Subject: **DR2018-00134 / TP2018-0010 Willamette Water Supply Program**

STAFF REPORT

PROPOSAL: **Willamette Water Supply Program
DR2018-00134 / TP2018-0010**

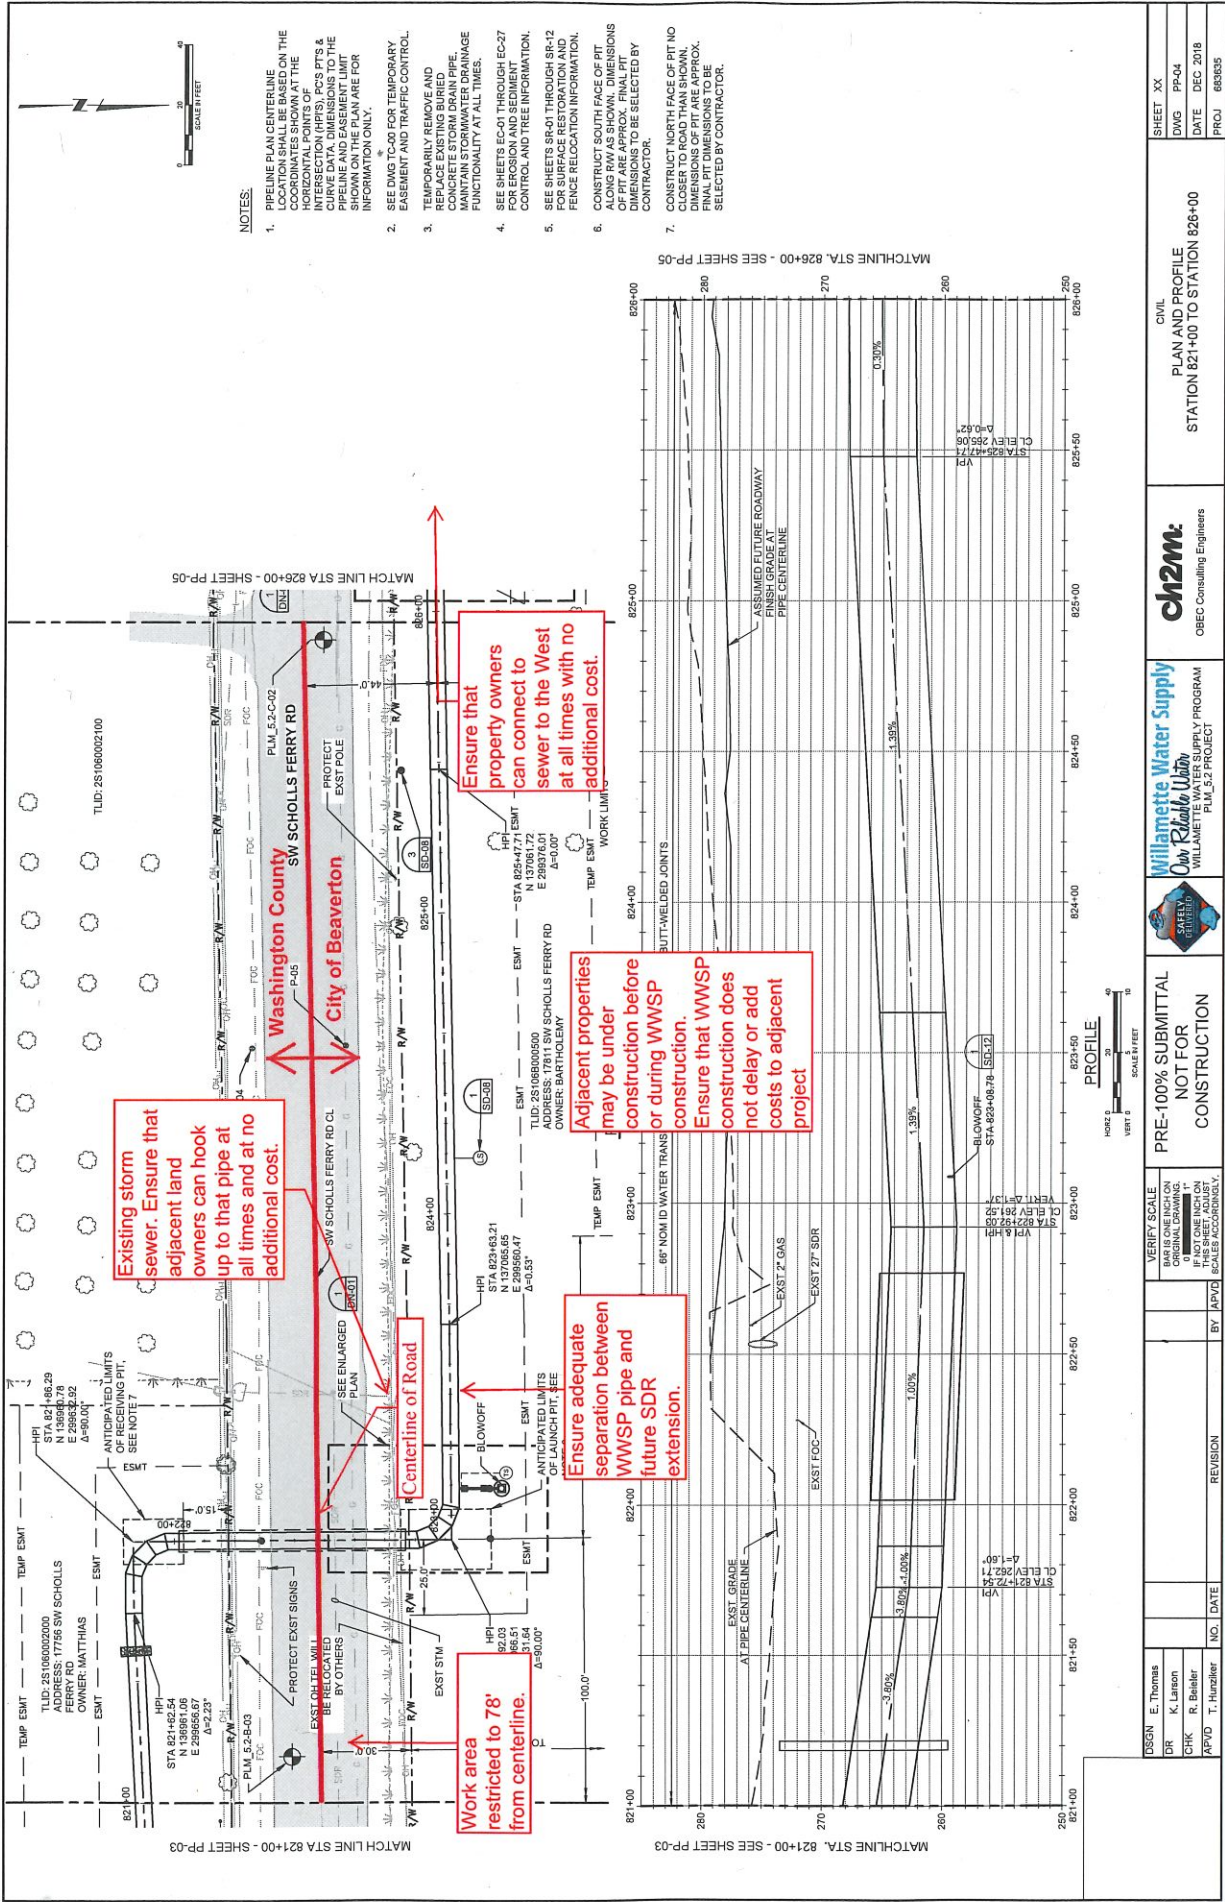
Exhibit 3.2 Email received from Desi Kurtz, 18485 SW Scholls Ferry Road on February 25, 2019, reiterating the concerns of Ed Bartholemy as outlined above in Exhibit 3.1, as well as a marked up site plan outlining specific areas of concern. As staff noted in the analysis of Exhibit 3.1, the concerns contained in this email do not warrant additional conditions of approval.

Thank you for listening to our concerns today. Here is an summary of what we discussed, I have put them on the plans of the project to help clarify what we were talking about.
